STORM SEWER PLAN
VILLAGE ON THE PARWAY
VILLAGE PARKWAY VENTURE
 ALBERT H. H. ZEE ASSOCIATES, INC., ENGINEERS
 CITY OF ADDISON, TEXAS

STORM SEWER PLAN
VILLAGE ON THE PARKWAY
VILLAGE PARKWAY VENTURE
 ALBERT H. HALFF ASSOCIATES, INC., ENGINEERS
CITY OF ADDISON, TEXAS

IRRIGATION, TELEPHONE & ELECTRICAL CONDUIT SLEEVE PLAN

WATER & SANITARY SEWER PLANS						
VILLAGE ON THE PARKWAY						
VILLAGE PARKWAY VENTURE						
ALBERT H. HALFF ASSOCIATES, INC. - ENGINEERS						
CITY OF ADDISON, TEXAS						
DESIGN	DRAWN	DATE	SCALE	NOTES	FILE	NO.
AHH	T.P.	MAY 1978	1"=50'	6143	4110	1960

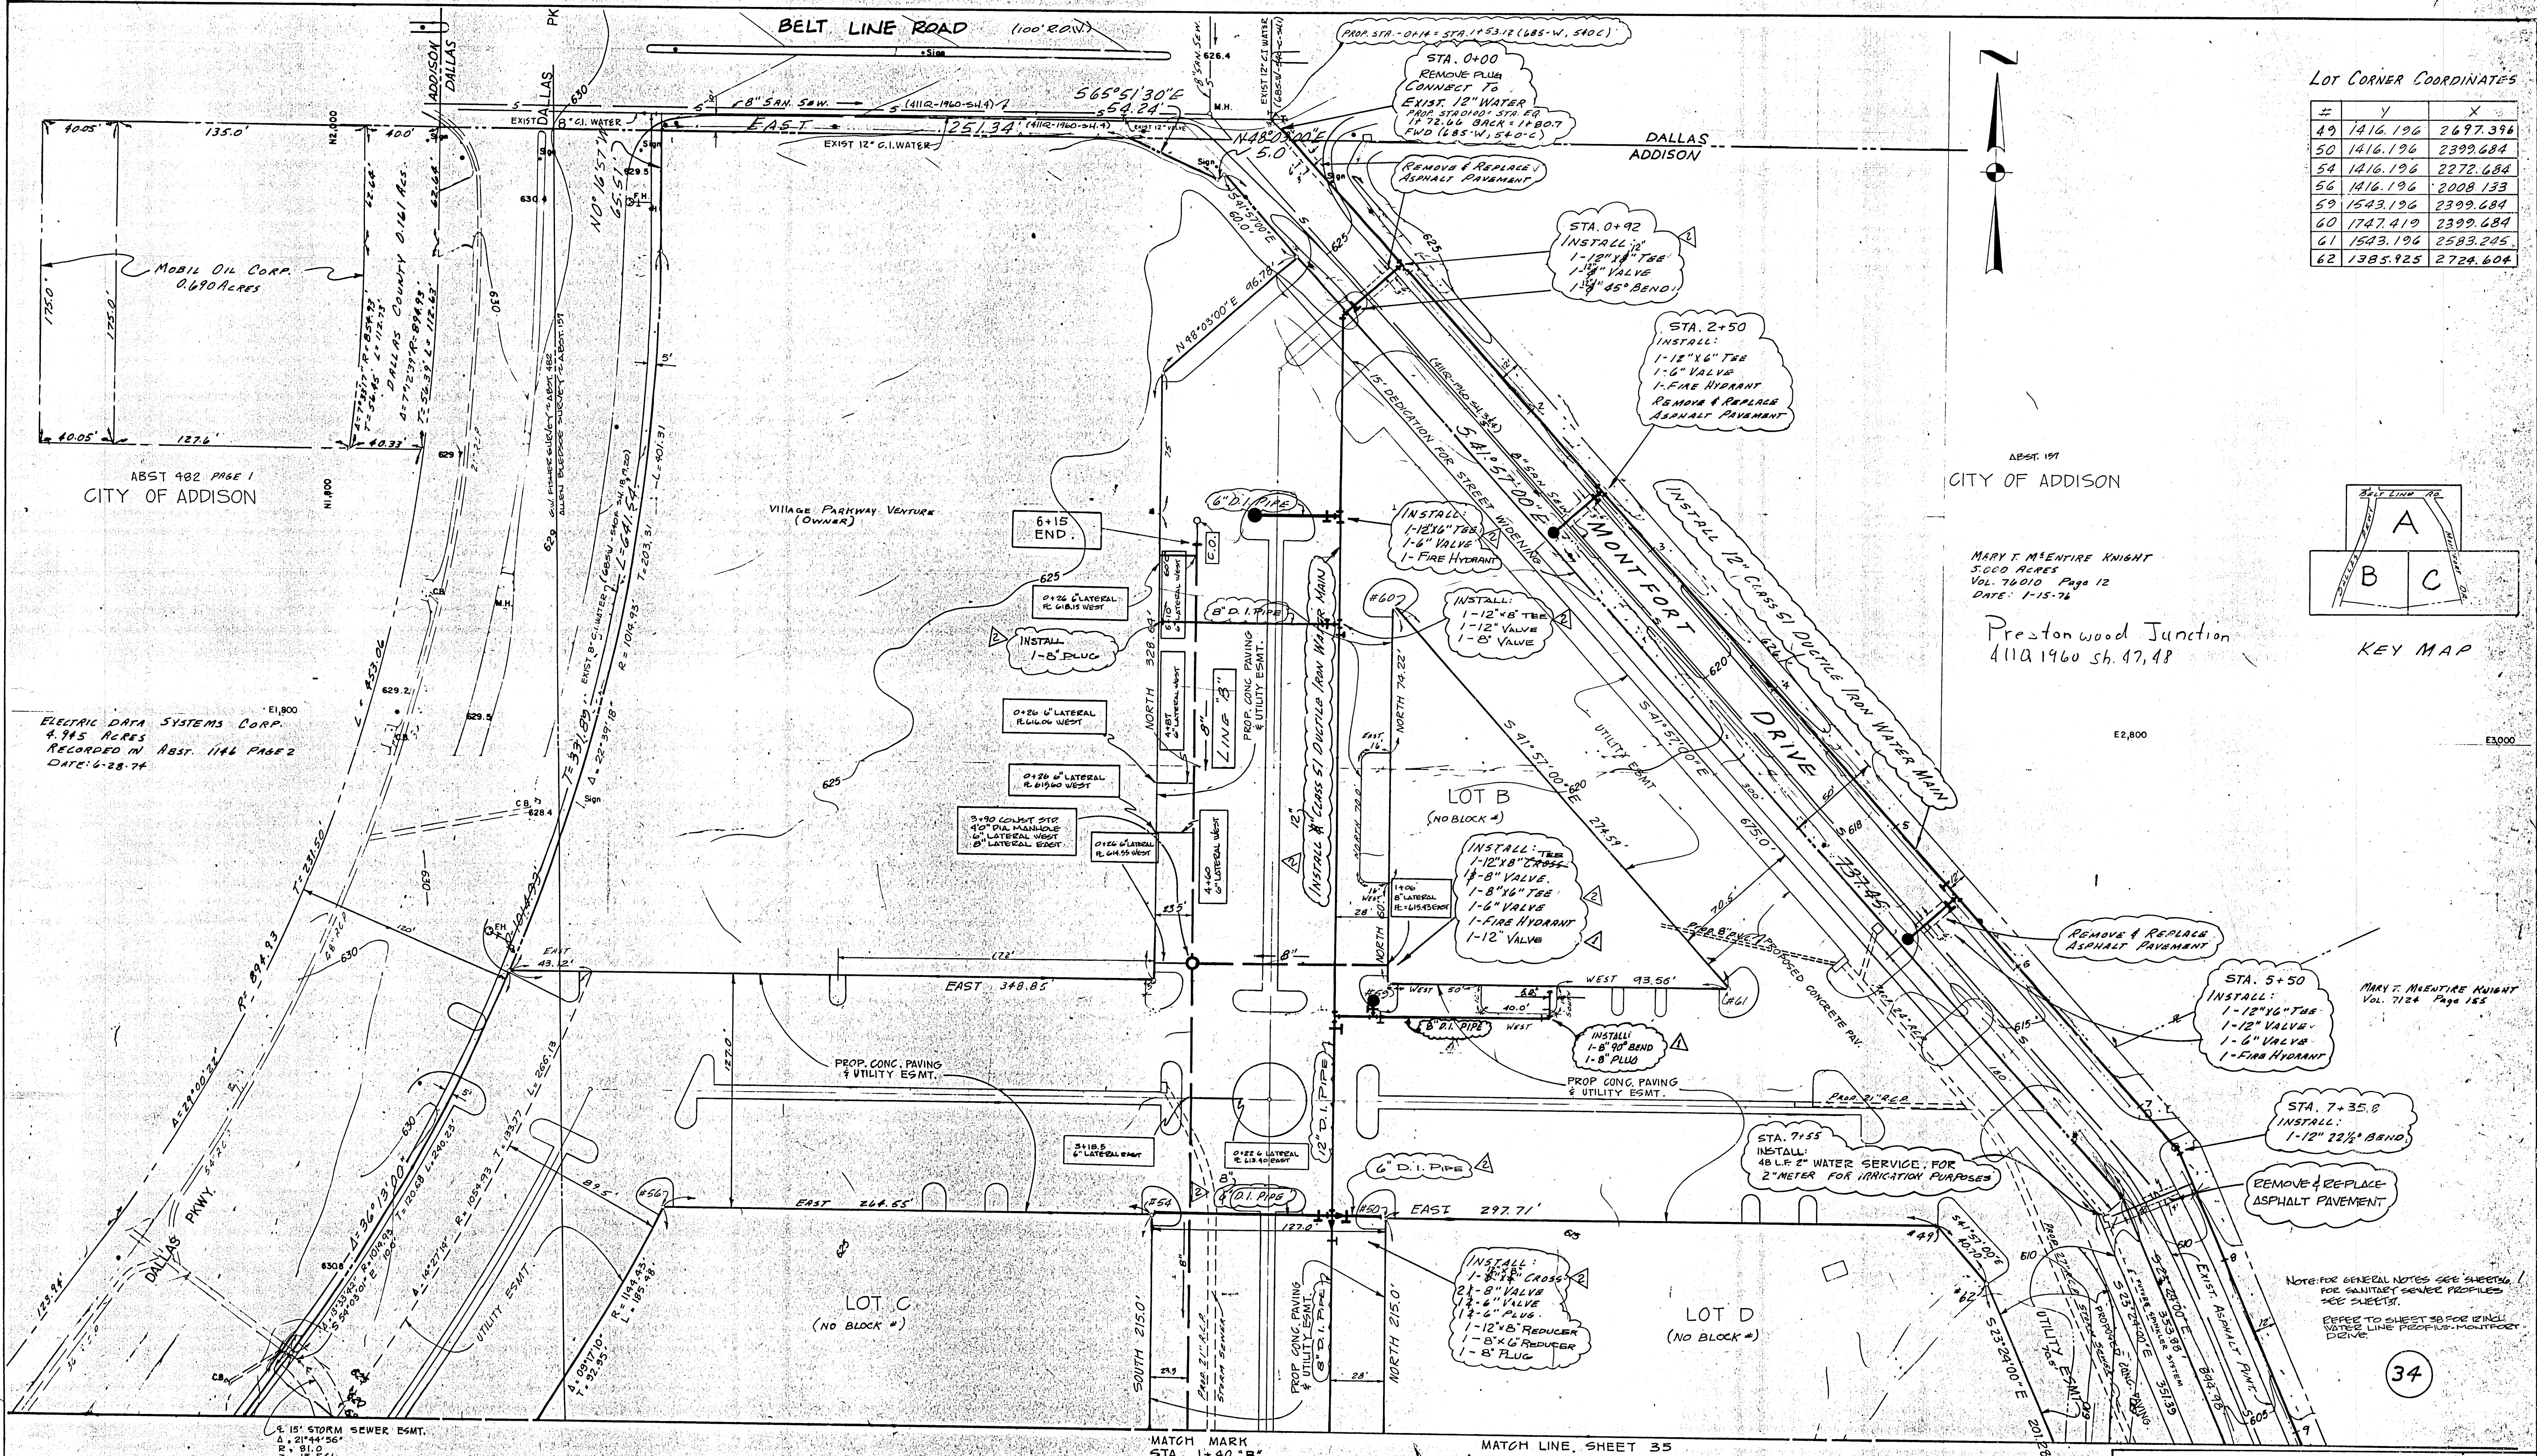
REVISOR: 1/31/79 CHANGED 8" WATER MAIN TO 12" MAIN BETWEEN LOT B & A-C, CHANGED FIRE HYDRANT AND SERVICE LINE LOCATIONS.
REVISOR: AS PER CHANGE ORDER #1 (1/1/79) (MOVED 8" WATER SERVICE FOR LOT B 85' EAST)

WATER & SANITARY SEWER PLANS						
VILLAGE ON THE PARKWAY						
VILLAGE PARKWAY VENTURE						
ALBERT H. HALFF ASSOCIATES, INC. ENGINEERS						
CITY OF ADDISON, TEXAS						
DESIGN	DRAWN	DATE	SCALE	NOTES	FILE	NO.
ALH	T.R.	MAY 1978	1"=40'	6143	6110	1960

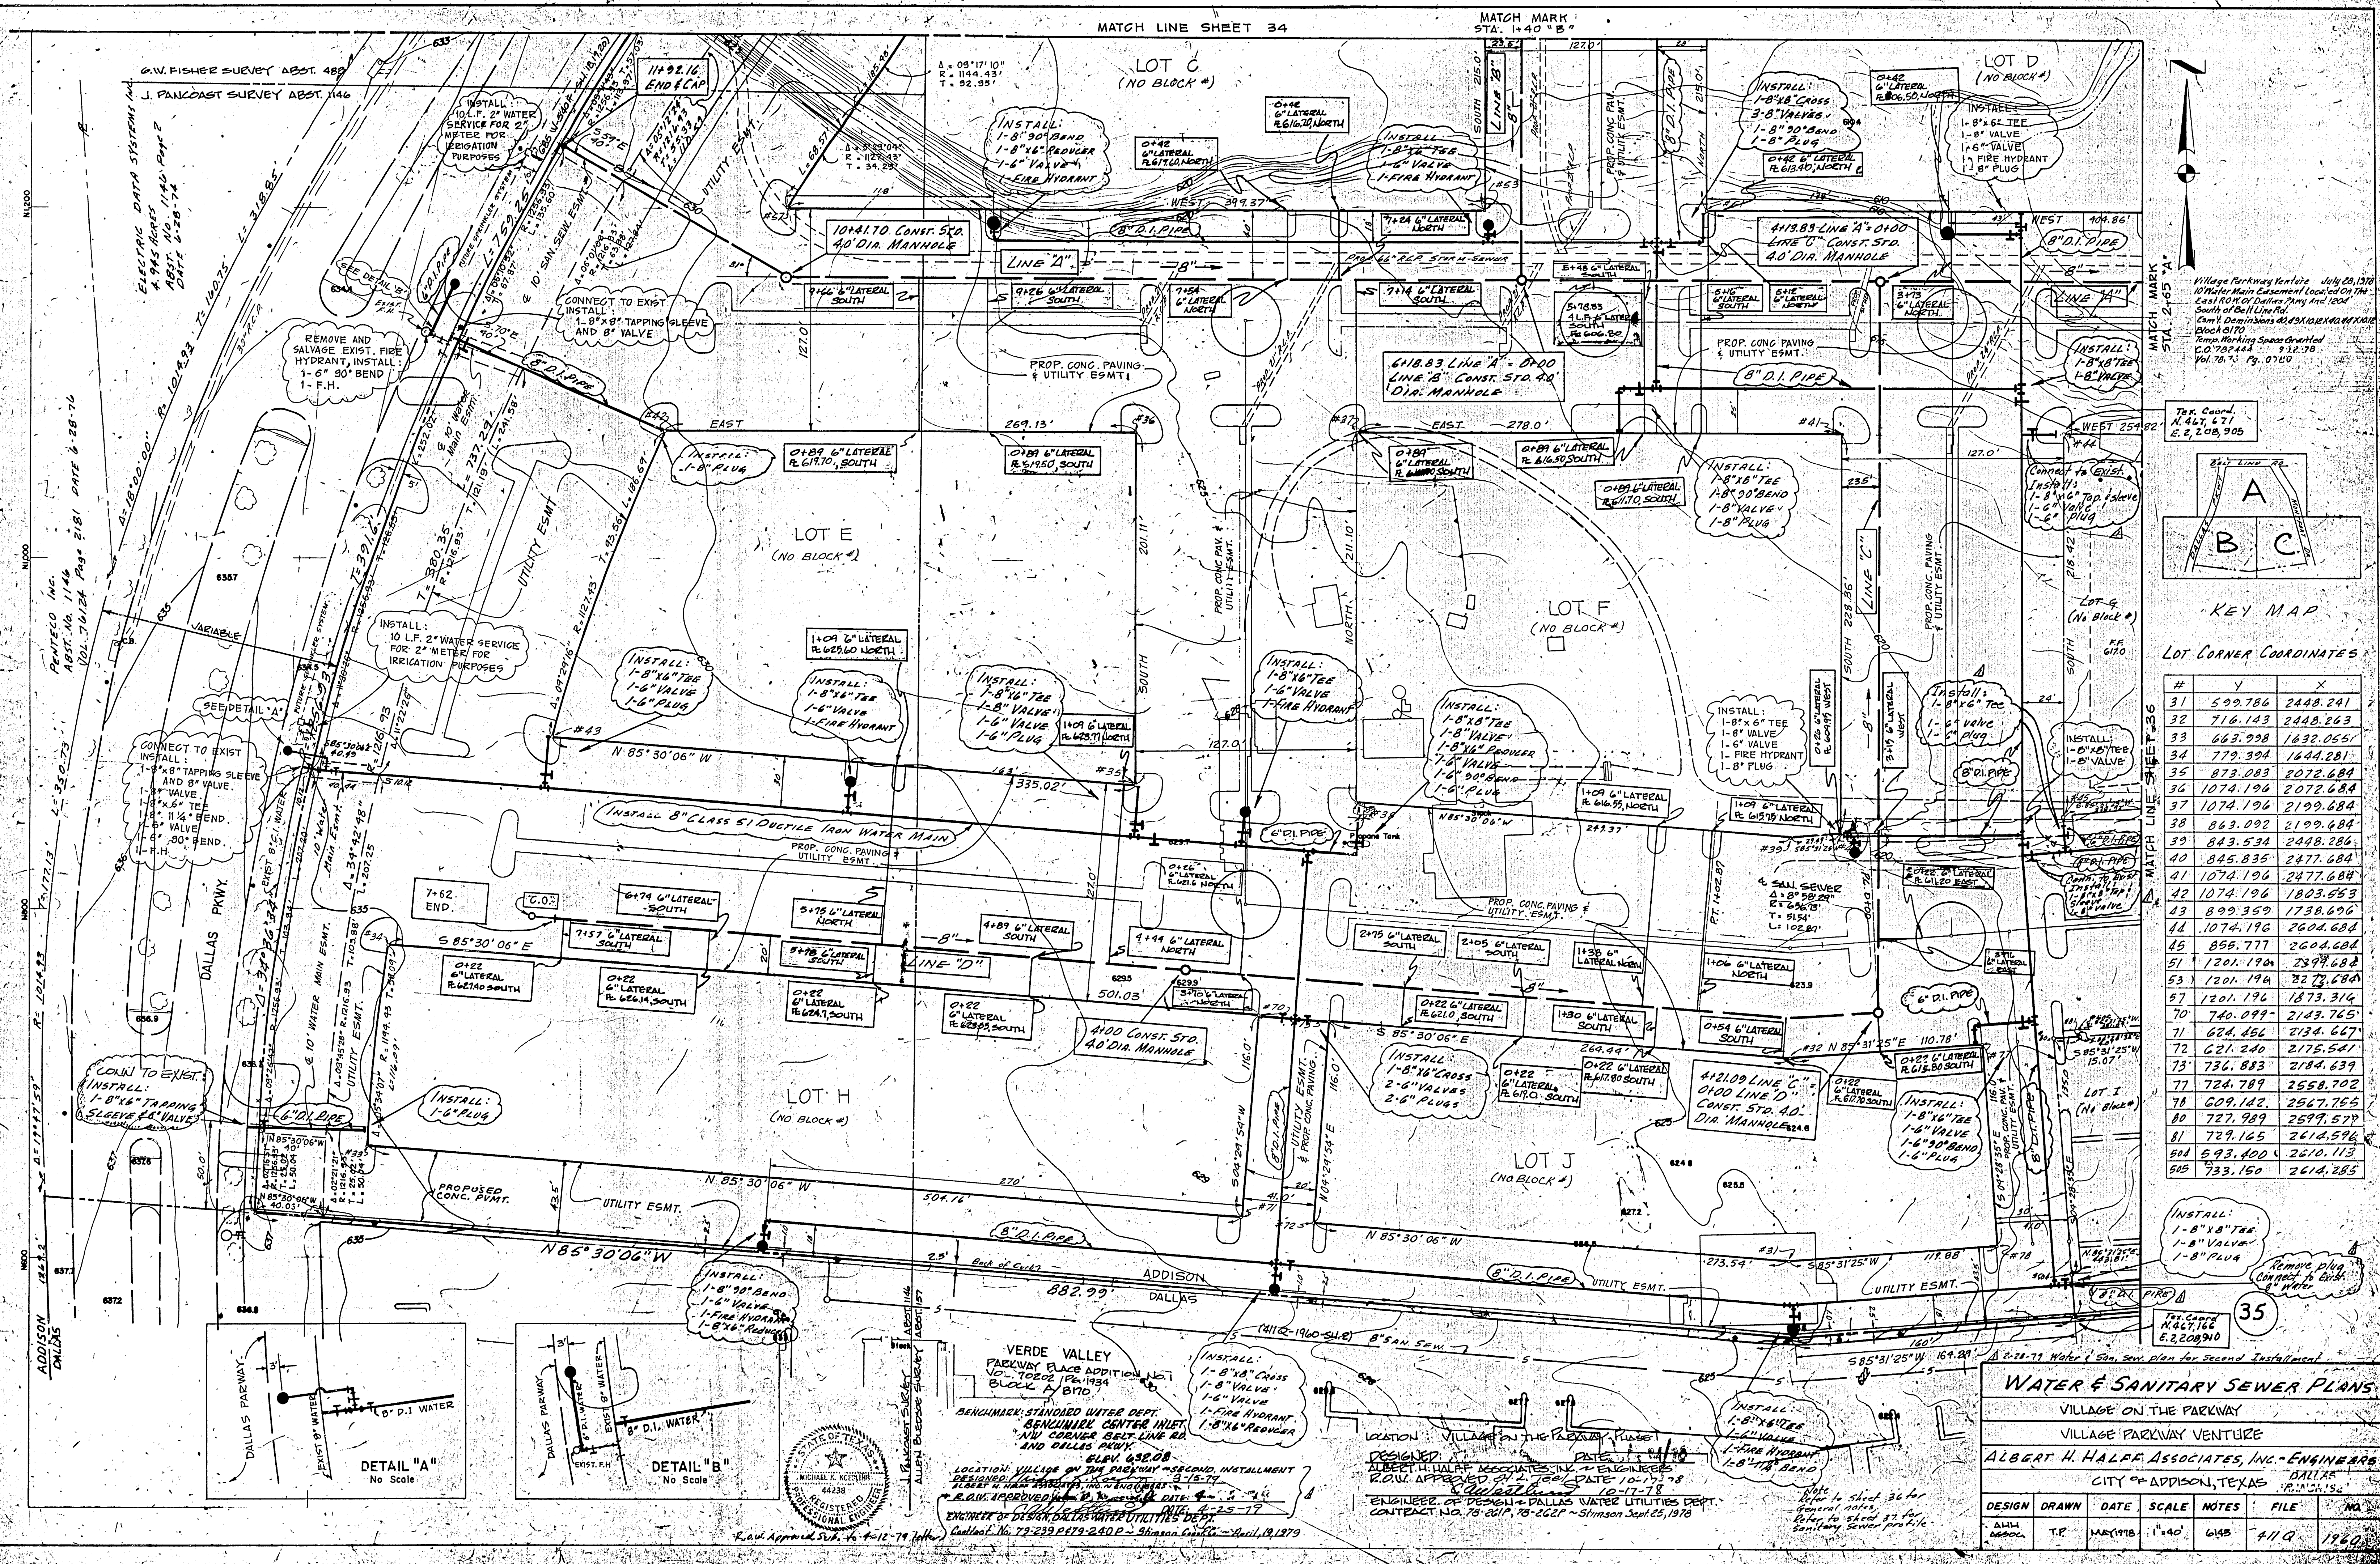
REVISED 1/31/79 CHANGED B WATER MAIN TO 12" MAIN BETWEEN LOT B & A-C, CHANGED FIRE HYDRANT AND SERVICE LINE LOCATIONS.
REVISED AS PER CHANGE ORDER #1 (1/11/79).
(MOVED B WATER SERVICE FOR LOT B 85' EAST)
